UNITED STATES PATENT AND TRADEMARK OFFICE

APPLICATION NO.	FILING DATE	FIRST NAMED INVENTOR	ATTORNEY DOCKET NO.	CONFIRMATION NO.
10/590,951	11/08/2006	Franz jun. Neuhofer	NEUHOFFER, JR.-16 PCT	3739
25889	7590	03/31/2009		
COLLARD & ROE, P.C. 1077 NORTHERN BOULEVARD ROSLYN, NY 11576			EXAMINER TRIGGS, ANDREW J	
			ART UNIT 3635	PAPER NUMBER
			MAIL DATE 03/31/2009	DELIVERY MODE PAPER

Office Action Summary	Application No. 10/590,951	Applicant(s) NEUHOFER, FRANZ JUN.	
	Examiner Andrew J. Triggs	Art Unit 3635

DETAILED ACTION

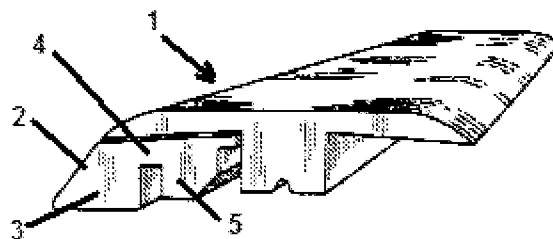
Regarding claim 2, Stanchfield teaches a covering device with a compensating strip that has a tongue and groove connecting mechanism but does not teach the compensating strip has two legs. However, Neuhofer teaches in the annotated figure below, a covering device (1) with a compensating strip (2) that has a basic form of an angle and two legs (3 and 4). In combination with Stanchfield, leg (4) would have the tongue and groove mechanism on it. Furthermore, it can be seen that the compensating strip (2) makes an extension of the cover (1) extending downward. One of ordinary skill in the art at the time of the invention would have been motivated to have a compensating strip with two legs because the legs form a continuation of the covering device that creates a smooth even flowing cover over a gap between panels. Therefore, the invention as a whole would have been obvious to one of ordinary skill in the art at the time of the invention.

Regarding claim 3, Stanchfield teaches a compensating strip but does not teach a supporting leg connected to the leg that has the tongue and groove mechanism. However, Neuhofer teaches in the annotated figure above, that the compensating strip (2) has a supporting leg (5) projecting from leg (4). In

The next argument is toward claim 3 as that the leg shown in the secondary reference is not a **supporting** leg. However, this argument is mere speculation of the reference because it does not show it supported on anything. However, if the leg of the reference was placed on a surface, it is certainly capable of providing support.
